**ROCHESTER SCHOOLS MODERNIZATION
PROGRAM PHASE III
DESIGN SERVICES FOR A PHASE 3C PROJECT
East Campus (Project # 103-039)
ADDENDUM #1**

**Prepared by
Rochester Joint Schools Construction Board (RJSCB)
27 May 2025**

Roof Plan

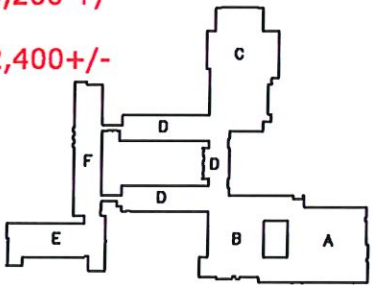
Question: Can you provide an aerial or plan of the proposed areas of roof replacement? The RFP indicates 78,244 sf of base bid roof replacement and an additional 13,843 for an alternate, the building footprint is roughly 215,000 sf

Answer: A plan view of the roof is provided with this Addendum

Roof Drawing for East Campus is attached.
